Request for Proposal (RFP)  
 Bid No: Bid 26-05-4136SB  
 Addendum No. 3

**Date:** June 19, 2026  
**To:** All Proposers  
**Subject:** Addendum No. 3  
 Consisting of Seventeen (17) Pages  
**RFP No.:** Bid 26-05-4136SB  
**Project Name:** N9073(1)1,2&4 Blue Canyon Road Project in Apache County, AZ  
**Owner:** Navajo Division of Transportation

## Addendum No. 3

STATE	PROJECT	SHEET NUMBER
AZ	N9073(1) 1, 2 & 4	77

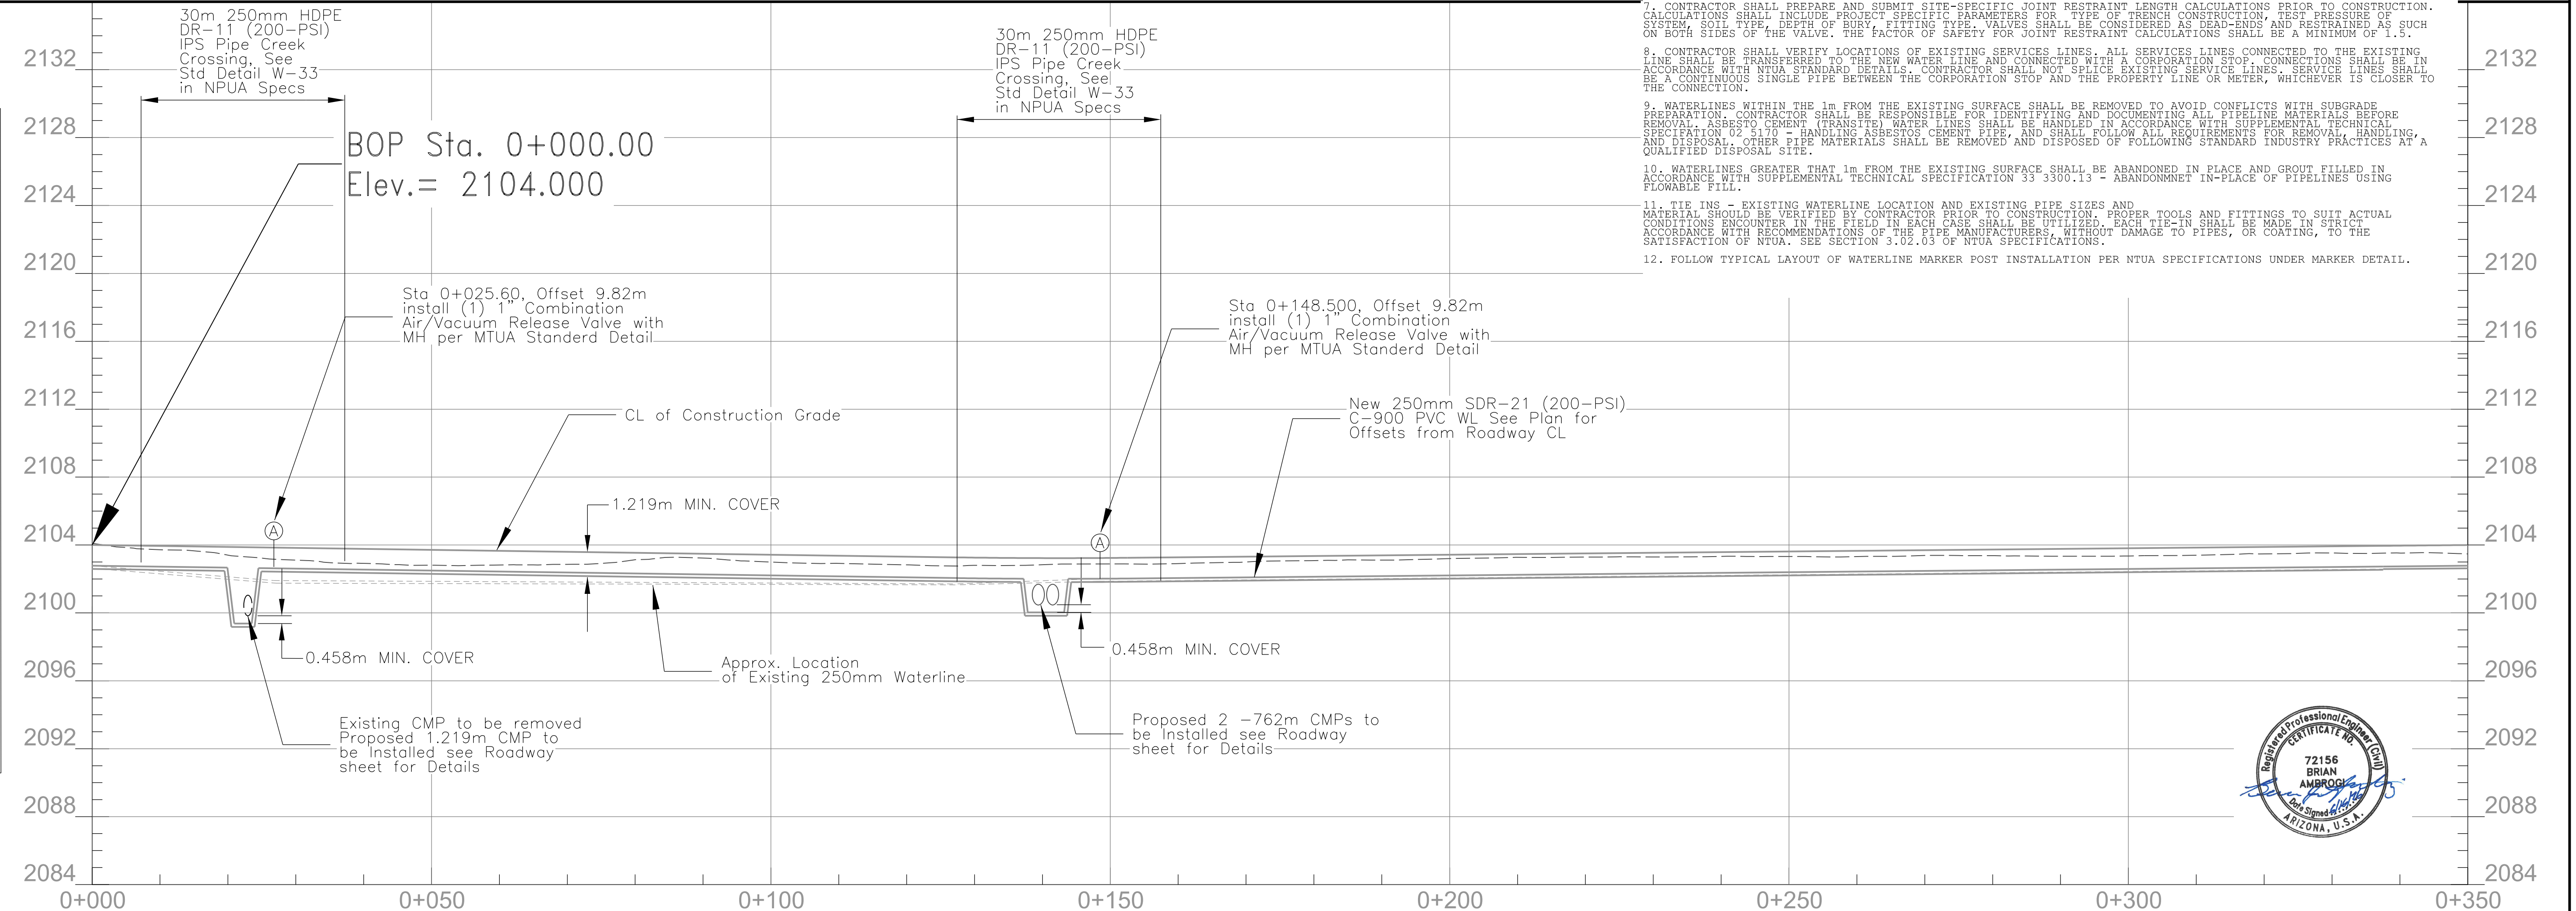
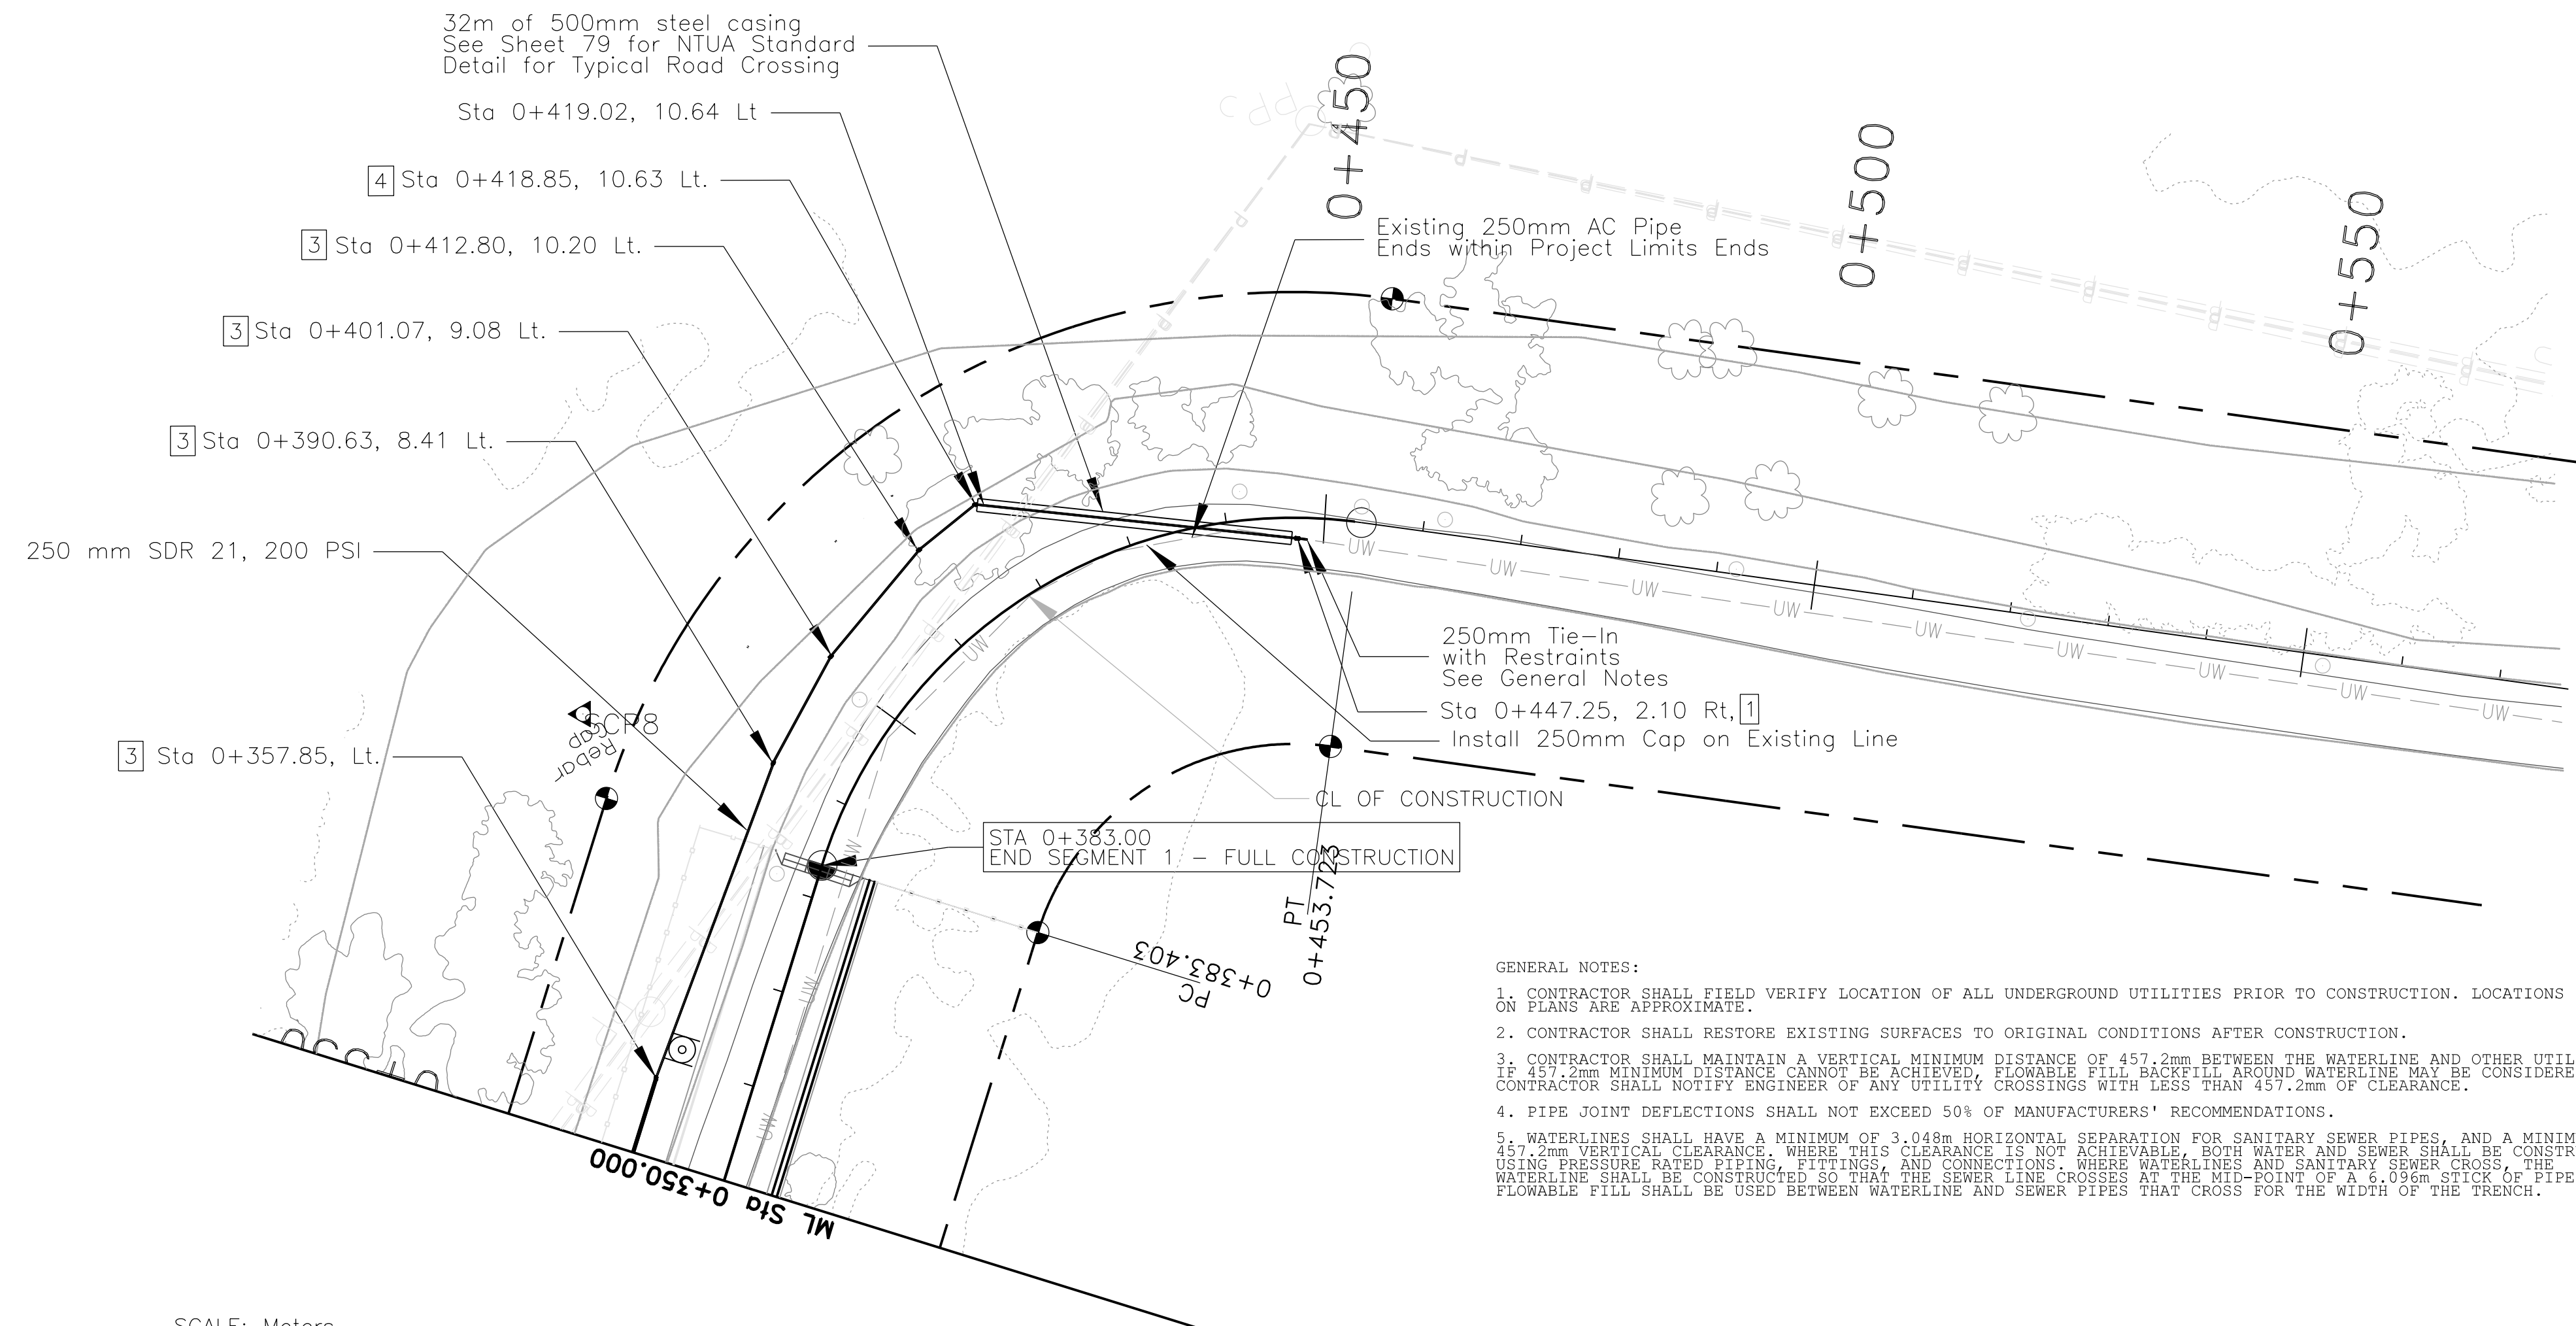
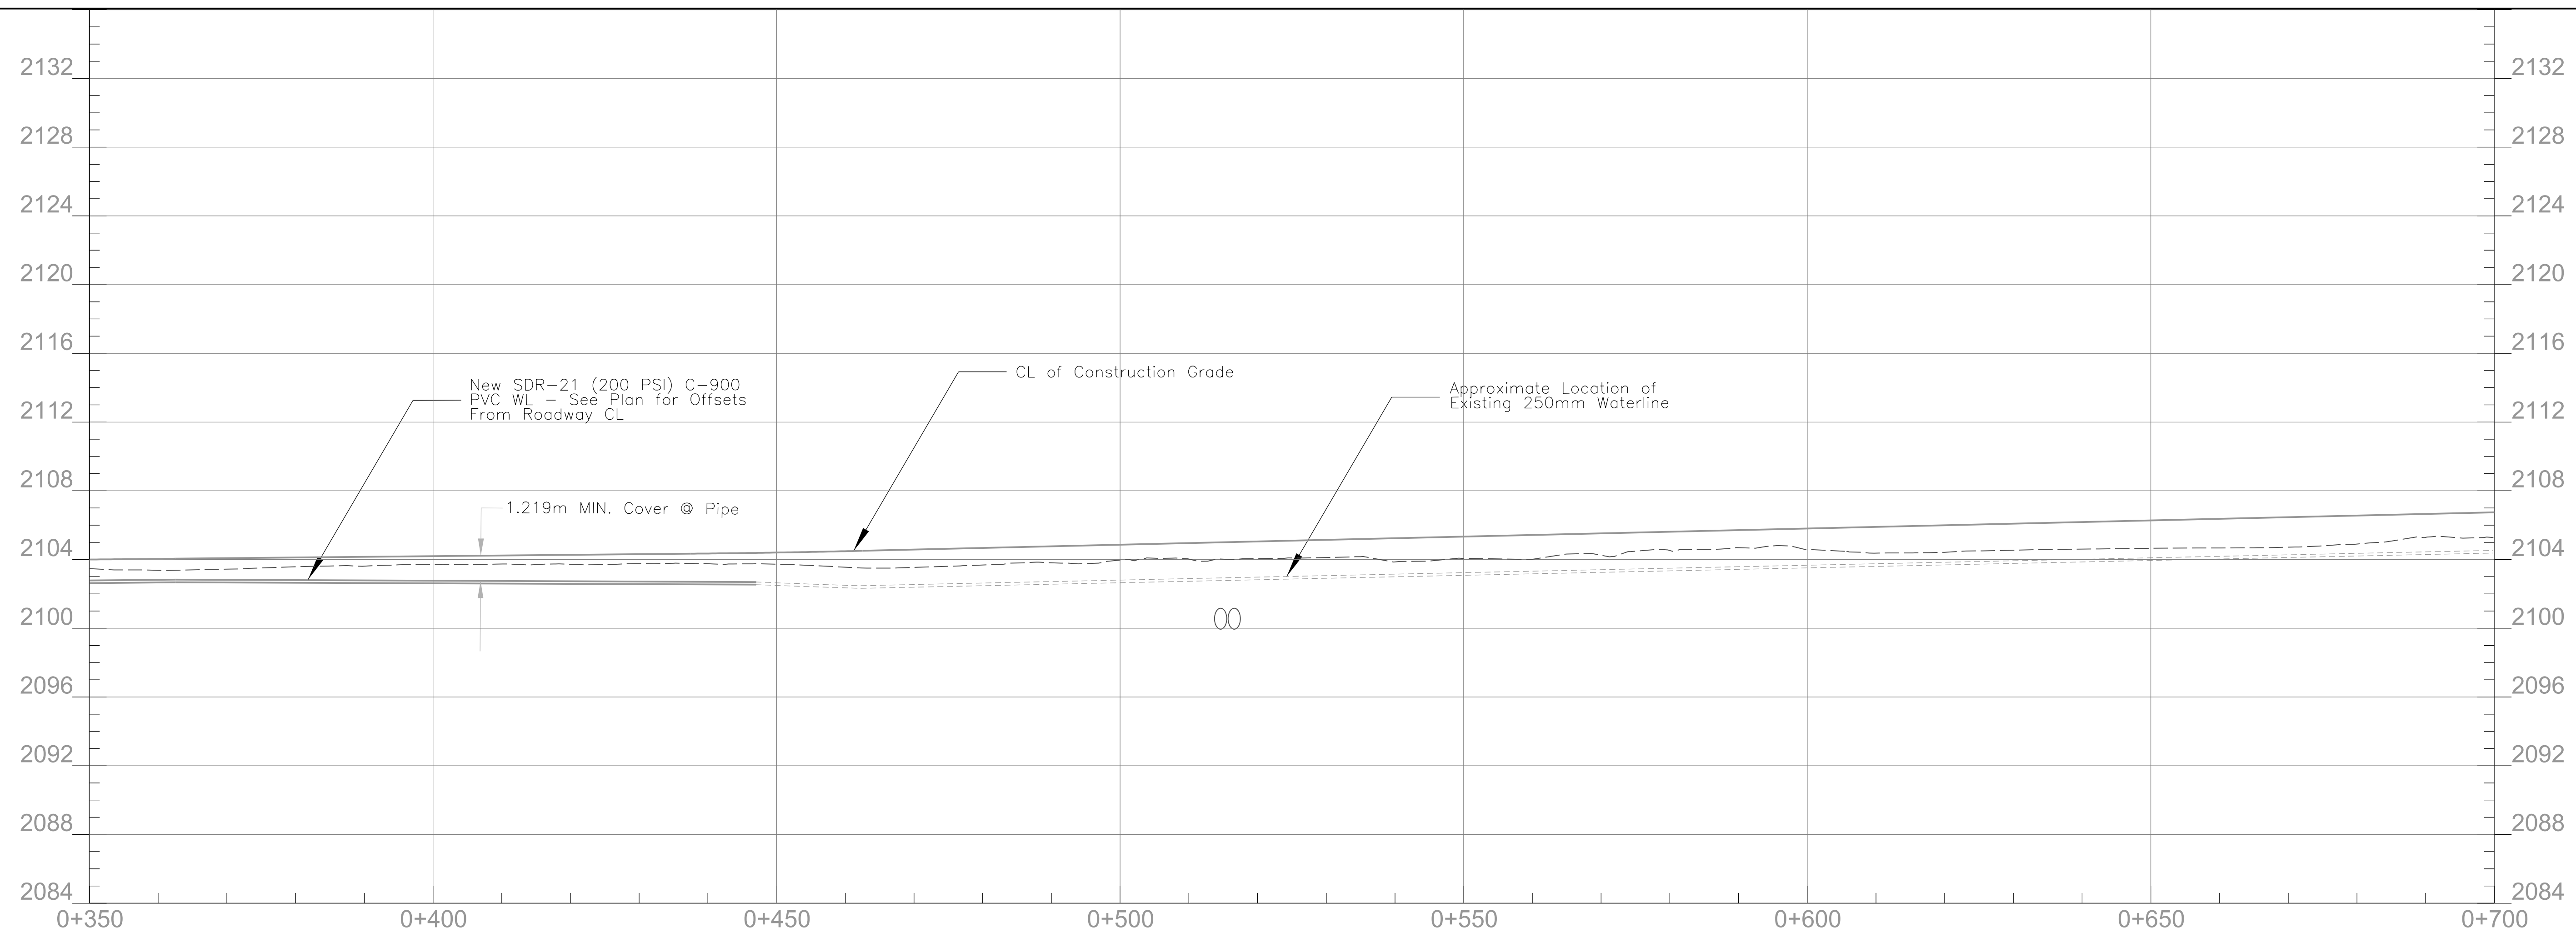
- The overall plans are being reviewed, and design revisions to the earthwork are being implemented. These implementations will be in a forthcoming addendum #4.
- Sheet 7 ESTIMATED QUANTITIES TABLES:
  - Revised to update the quantity for Bid Item No. 25302-100 Gabions, Aluminized Coated, Class 2 to 9,335 m<sup>3</sup>.
  - Revised for the updated NTUA waterline relocation design.
- Sheet 33A: Revised to update the quantity for Bid Item No. 25302-100 Gabions, Aluminized Coated, Class 2 to 9,335 m<sup>3</sup>, removing segment 2.
- Sheets 77-80: Revised for the updated NTUA waterline relocation design.
